Well Name: AXI APACHE H	Well Location: T23N / R5W / SEC 6 / SWSE / 36.250225 / -107.399575	County or Parish/State: RIO ARRIBA / NM
Well Number: 14	Type of Well: CONVENTIONAL GAS WELL	Allottee or Tribe Name: JICARILLA APACHE
Lease Number: JIC38	Unit or CA Name:	Unit or CA Number:
US Well Number: 3003905149	Well Status: Temporarily Abandoned	Operator: DJR OPERATING LLC

Notice of Intent

Type of Action: Plug and Abandonment

**Plug and Abandonment Procedure
for
DJR Operating, LLC
AXI Apache H 14
API # 30-039-05149
SW/SE, Unit O, Sec. 6, T23N, R5W
Rio Arriba County, NM**

DJR Operating, LLC
Proposed Wellbore Diagram
AXI Apache H 14
API # 30-039-05149
SW/SE, Unit O, Sec 6, T23N, R5W
Rio Arriba County, NM

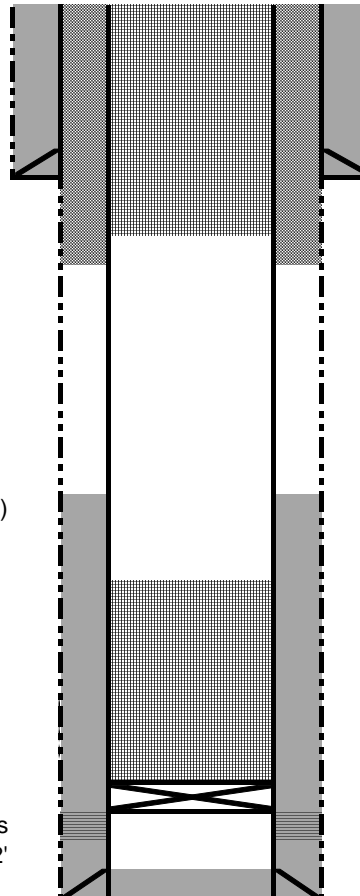
- The plugs proposed in the P&A procedure will adequately protect any freshwater sands in this well bore.
- Only a Gamma Ray Lithology/ Neutron Porosity (1518.8' – 2435.7') raster log. Went with the operator tops. Appropriate for this area.
- Pictured Cliffs perms 2227' – 2262'.

You are also required to place cement excesses per 4.2 and 4.4 of the attached General Requirements.
